## REQUEST FOR TENDER NO. C003018

### RFT for Principal / Head Works Contractor – Hume Repository Northern Extension

#### Addendum No. 02 – 17 July 2024

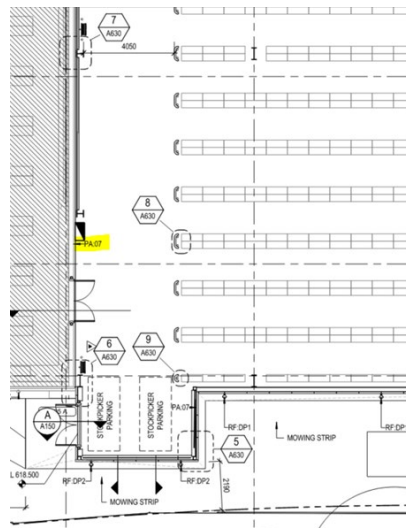
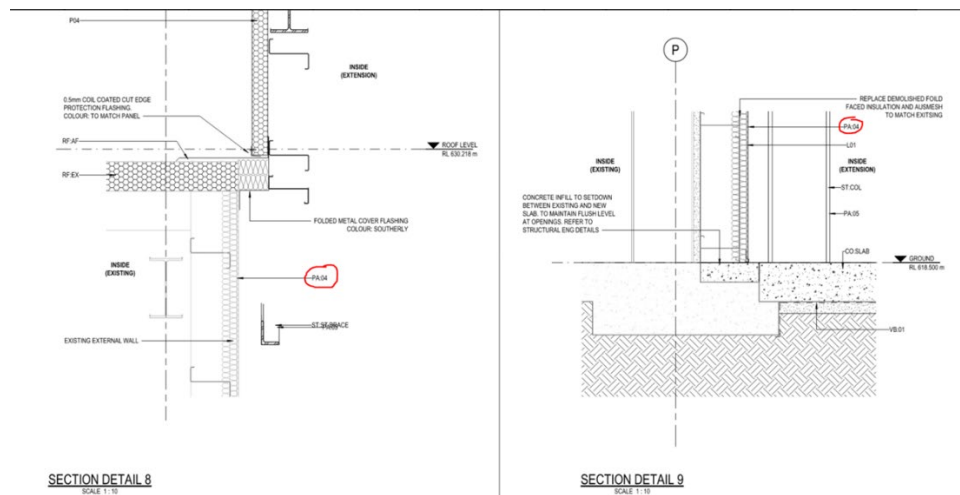
06	<p><b>Question:</b> <i>The Civil Drawing C1010, titled 'Bulk Earthworks Plan [A1]', illustrates a cut of 91 cubic meters and a fill of 297.30 cubic meters. In contrast, Drawing S050, titled 'Footing Plan [B]', in notes 3 and 4, specifies the extraction of uncontrolled fill up to a depth of 2 meters. Could you please clarify whether the removal of this uncontrolled fill extends beneath the area of the new warehouse slab, or is it confined only to the area beneath the footings only?</i></p> <p><b>Answer:</b> The contractor is to allow for a batter to the western end of the existing building. Also allow for the removal of uncontrolled fill to the full extent of the new warehouse slab as noted on drawing S050. This is in addition to the figures supplied on drawing C1010. The civil drawing will be amended at issue for construction.</p>
